Title - Sujet Redev. of Floor B1 -Sinclair Centre	
Solicitation No. - N° de l'invitation EZ899-122573/A	Amendment No. - N° modif. 003
Client Reference No. - N° de référence du client	Date 2012-02-22
GETS Reference No. - N° de référence de SEAG PW-\$PWY-020-6584	
File No. - N° de dossier PWY-1-34396 (020)	CCC No./N° CCC - FMS No./N° VME
Solicitation Closes - L'invitation prend fin at - à 02:00 PM on - le 2012-02-29	Time Zone Fuseau horaire Pacific Standard Time PST
F.O.B. - F.A.B. Plant-Usine: <input type="checkbox"/> Destination: <input checked="" type="checkbox"/> Other-Autre: <input type="checkbox"/>	
Address Enquiries to: - Adresser toutes questions à: Ly, Ronny(PWY)	Buyer Id - Id de l'acheteur pwy020
Telephone No. - N° de téléphone (604) 666-0043 ()	FAX No. - N° de FAX (604) 775-6633
Destination - of Goods, Services, and Construction: Destination - des biens, services et construction: Services Canada - Sinclair Centre, Vancouver, B.C.

ADDENDUM #2

REVISE THE ARCHITECTURAL SPECIFICATIONS AS FOLLOWS:

Add detail "1" as per attached sketch ASK-02.

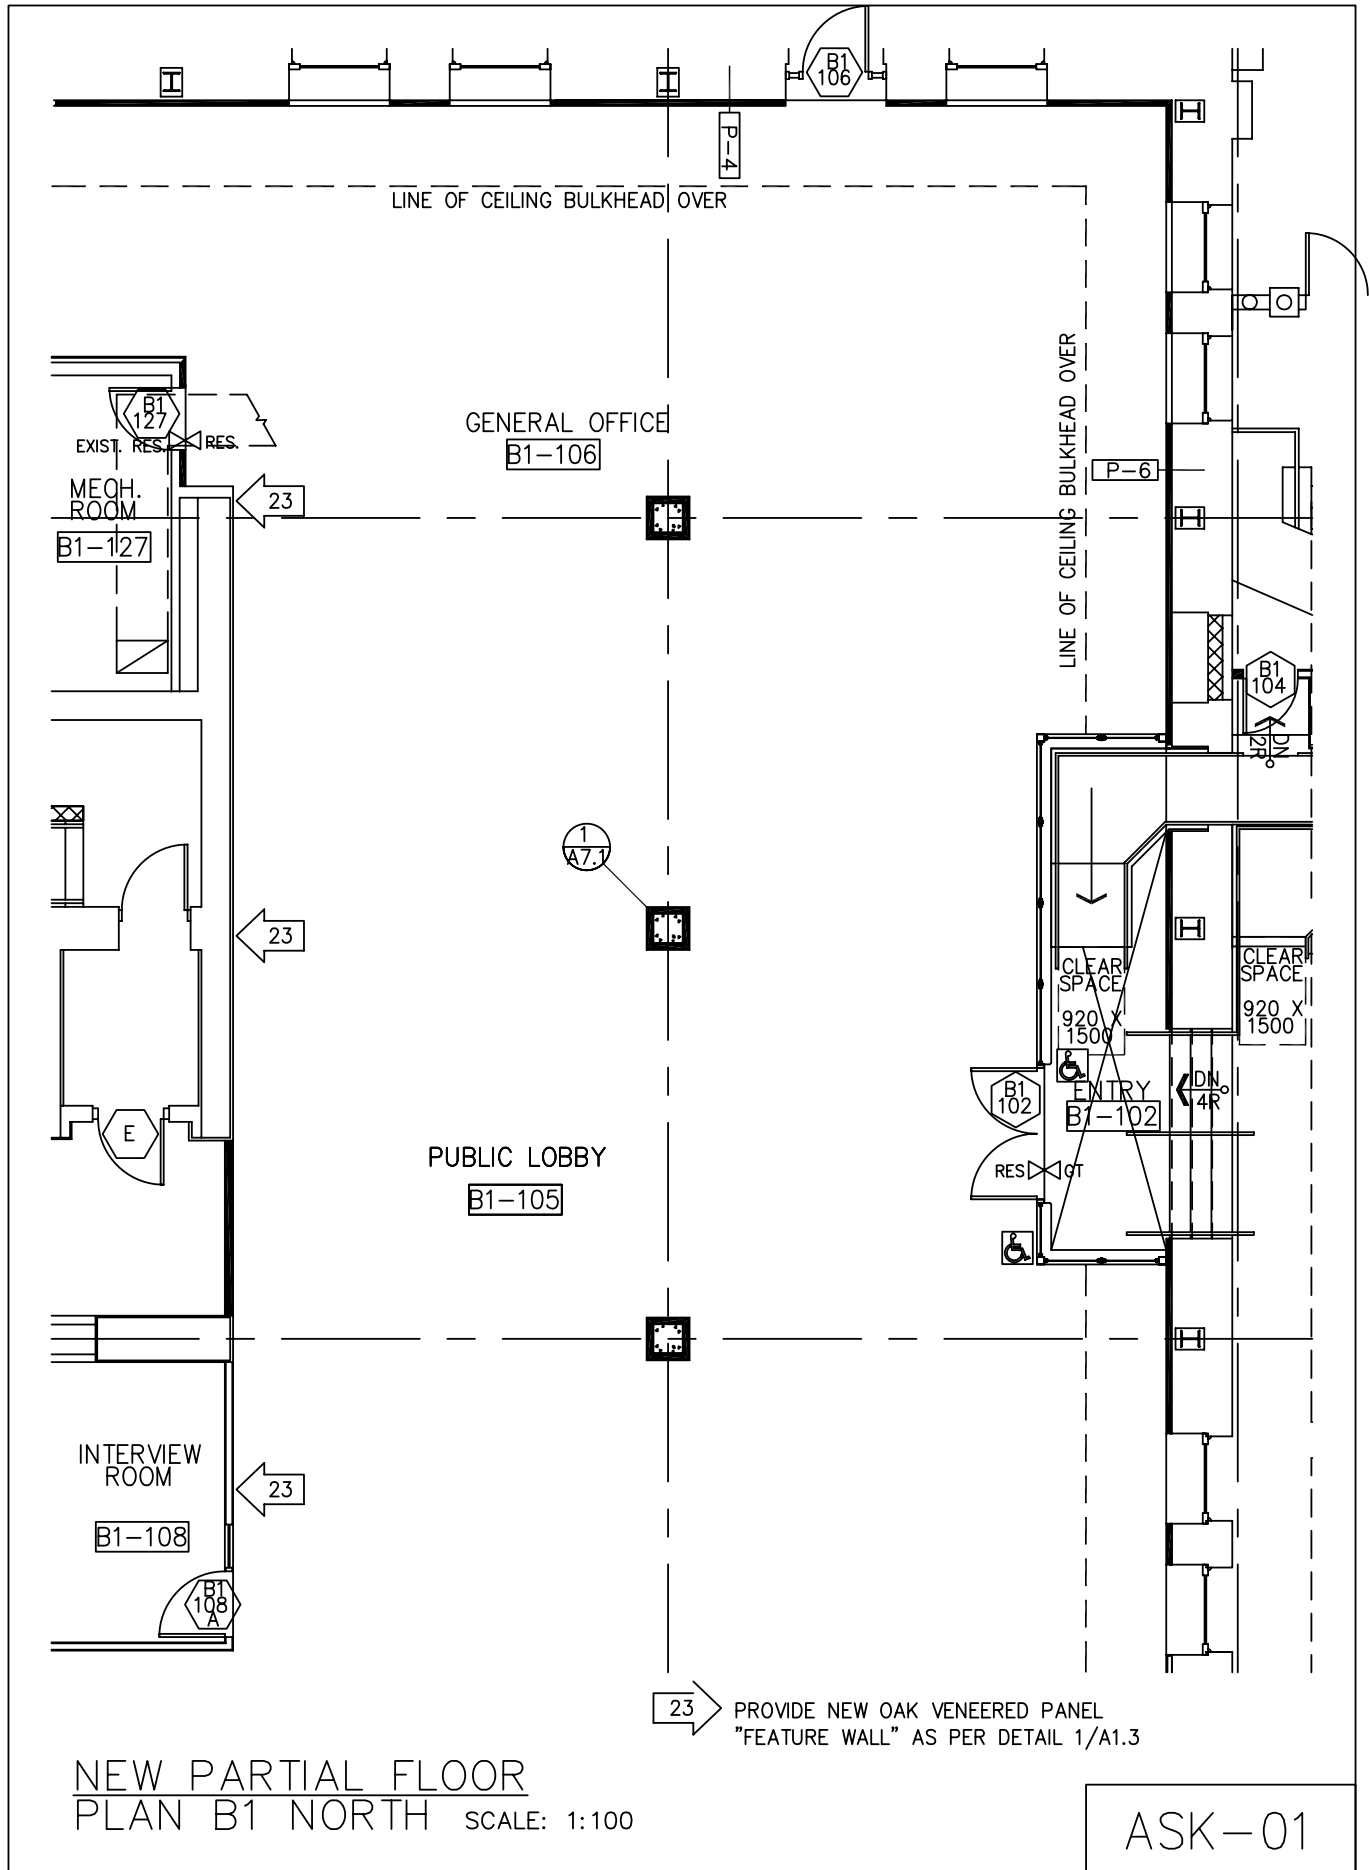
2. Drawing A1.3:
Construction Notes, Add note 23 to read as follows:

"23 Provide new oak veneered panel 'feature wall' as per detail 1/A1.3."

4. Drawing A1.3:
